South Texas Project Electric Generating Station P.O. Box 289 Wadsworth, Texas 77483

April 7, 2016
NOC-AE-16003351
10 CFR 50.90

South Texas Project
Unit 1
Docket No. STN 50-498
License Amendment Request to Revise Technical Specification 5.3.2 to
Allow Operation with 56 Full-Length Control Rod Assemblies for Unit 1

Subject: License Amendment Request to Revise Technical Specification 5.3.2 to Allow Operation with 56 Full-Length Control Rod Assemblies for Unit 1

Figure 1: Control Rod Locations

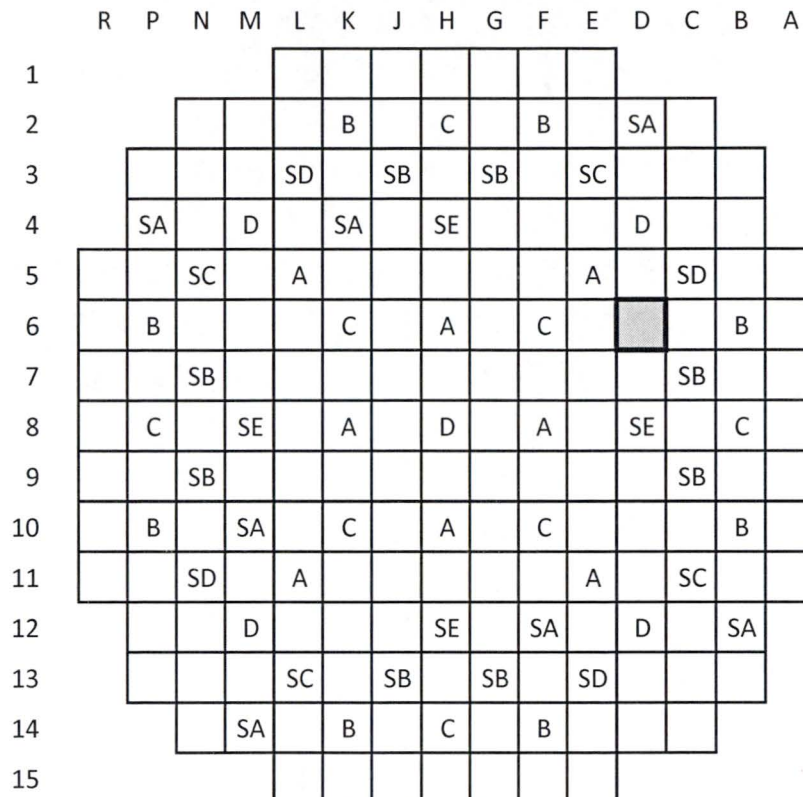
Prior to its removal for Unit 1 Cycle 20 (Reference 6.54), Control Rod D-6 was located in Shutdown Bank A and was located in the core as shown in Figure 1.

The proposed amendment would revise TS 5.3.2, "Control Rod Assemblies," to require Unit 1 to operate with 56 full-length control rod assemblies with no full-length control rod assembly in core location D-6, in lieu of the requirement to contain 57 full-length control rod assemblies. STPNOC is also proposing to remove the footnote, which permitted the Unit 1 Cycle 20 core to contain 56 full-length control rod assemblies with no full-length control rod assembly installed in core location D-6. STPNOC performed a thorough review of the TS and has determined that no other TS changes are required.
